Integrated Issue Resolution Status Report

Chapters 1 through 8

U.S. Nuclear Regulatory Commission
Office of Nuclear Material Safety and Safeguards
Washington, DC 20555-0001

Manuscript Completed: March 2005
Date Published: April 2005

Figure 4.1.3-1. Portions of Nevada Test and Training Range (NTTR), Federal Airways, Military Training Routes (MTRs), and Low-Altitude Training Navigation Area (LATNs)
(Adopted from Bechtel SAIC Company, LLC, 2002b, Figure 16)

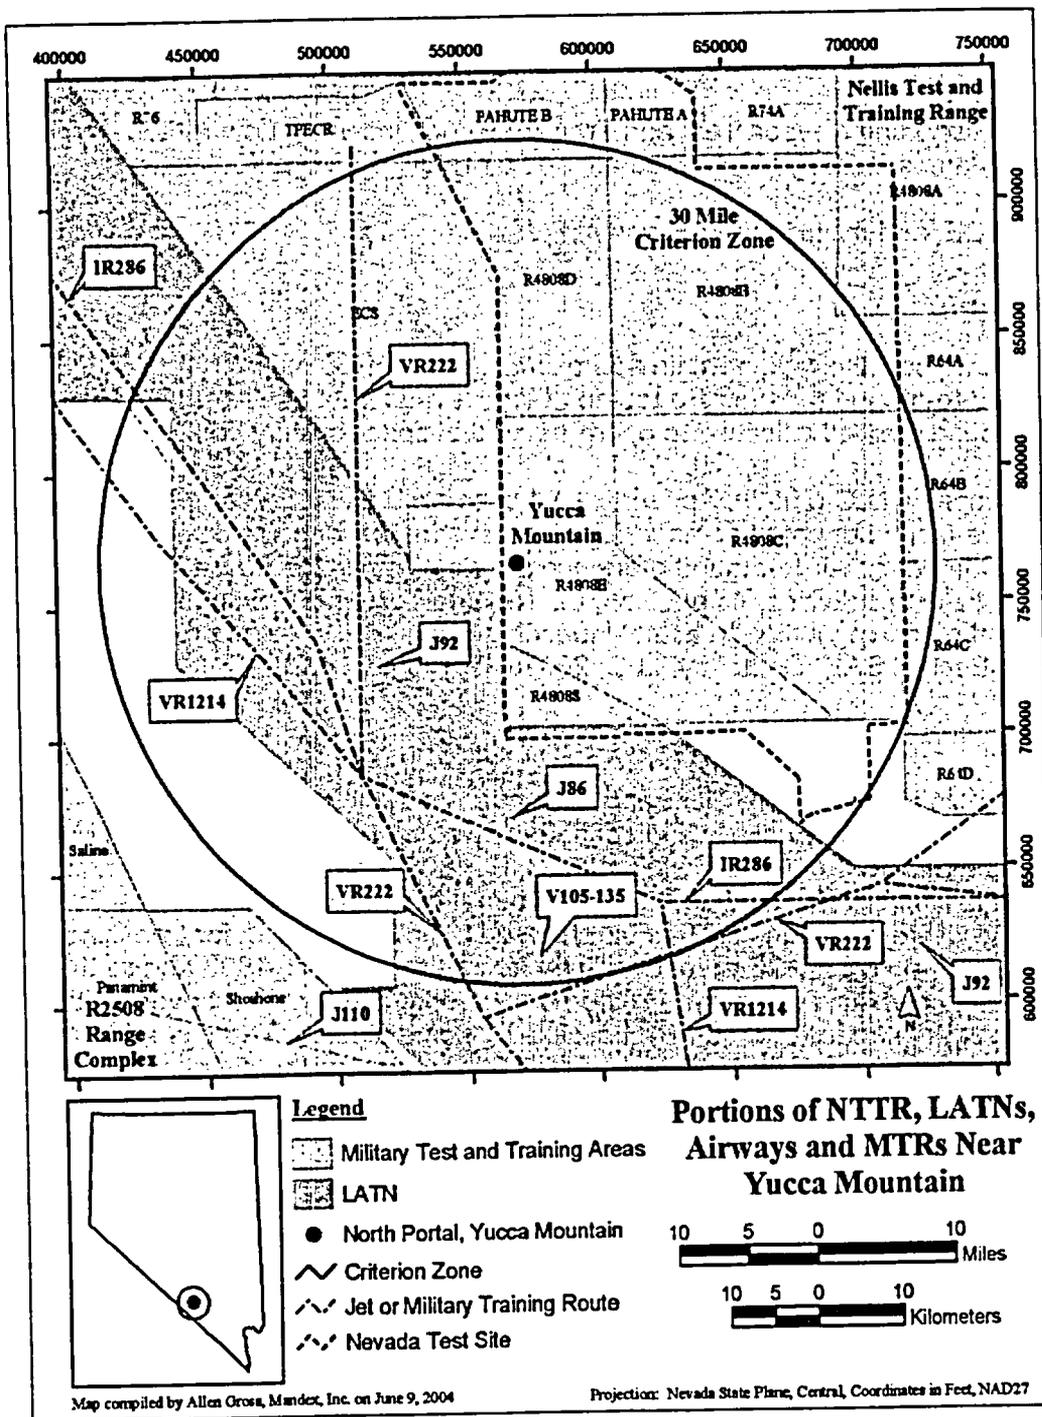
Bechtel SAIC Company, LLC (2002b, Section 5.1.2.2) states that aircraft flying through the airspace above the Nevada Test Site are not restricted to any specific corridor; however, this is only an assumption in the analysis conducted by Kimura, et al. (1998). DOE should provide the basis that supports this statement.

- DOE should explain the rationale for assuming the width of the aviation corridor to the southwest of Yucca Mountain to be equal to 38.4 km [24 mi] in CRWMS M&O (2003a). DOE should clarify whether this assumed width belongs to Federal airway V105-135, J86, J92, VR1214, or IR286 (Bechtel SAIC Company, LLC, 2002b, Figure 16). DOE should clarify whether the assumed width of the airway is the same as used by the Federal Aviation Administration, as discussed previously.
